STAFF REPORT

TO: City Council
FROM: Ben Prchal, City Planner
AGENDA ITEM: Conditional Use Permit Amendment for Cedar Pet Clinic – 11051 Stillwater Blvd.
REVIEWED BY: Ben Prchal, City Planner

Re: Cedar Pet Clinic: 11051 Stillwater Boulevard
Engineering Site Plan Review

To: Ben Prchal, City of Lake Elmo Planner
From: Lucius Jonett, Wenck Landscape Architect
Date: October 12, 2018
Subject: City of Lake Elmo Landscape Plan Review
Cedar Pet Clinic Conditional Use Permit Amendment, Review #1

1 LANDSCAPE PLAN
SCALE: 1" = 20'

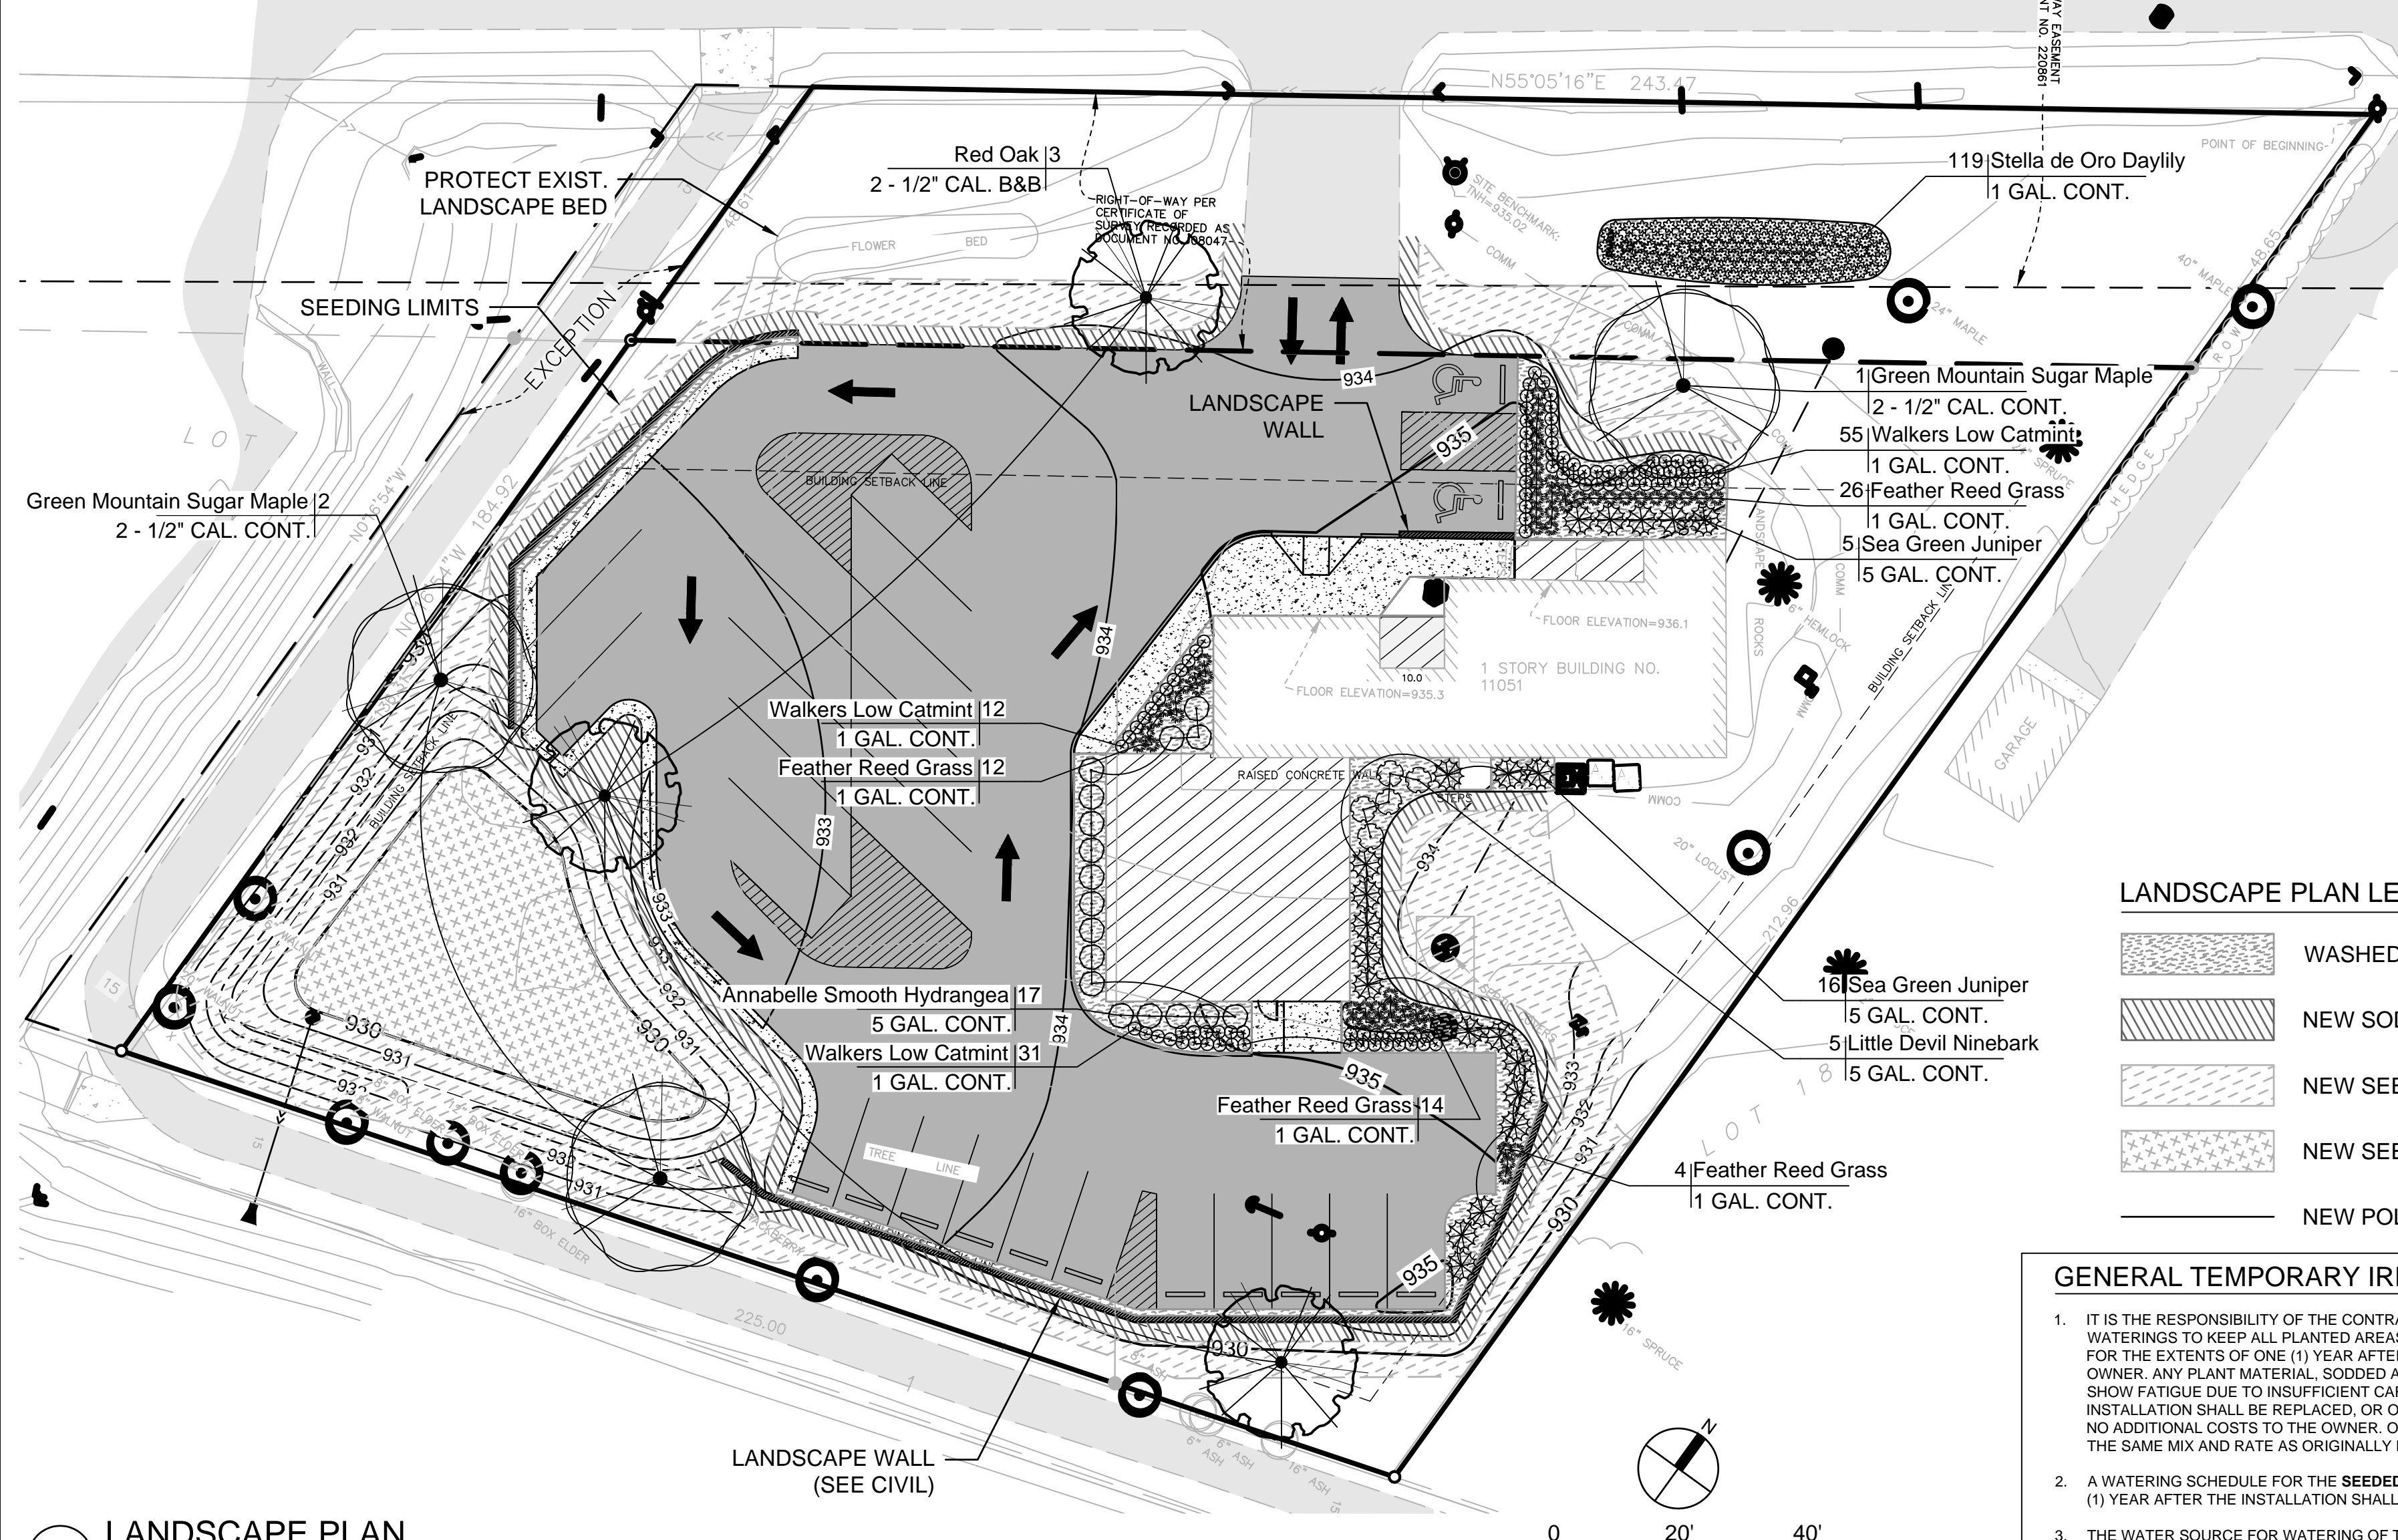
Landscape Plans. The applicant has submitted landscape plans showing the proposed landscaping for the property. After reviewing the site they will need to provide more trees than what is shown on the plans. After applying the updated environmental performance code, further information to confirm staff review is needed.

The provided landscape plan does not meet the code required number of trees. The proposed phase 1 plans show more than the code required tree quantities.

- A. A landscape plan has been submitted that does not include all requirement: .
1. The landscape plan does not include required City standard notes and details.
 2. All utilizes and pavements are not shown on the landscape plan to review for tree placement conflicts.

3. Provide the required 13 coniferous trees, that are 6' tall or greater, for mitigation in the landscape plan.
4. In addition to the 13 required coniferous trees, at least 5 deciduous trees are required to meet the 25% coniferous and 25% deciduous tree minimum composition.

5. Landscape plan needs to be updated to show utilities and to include City standard notes and details.
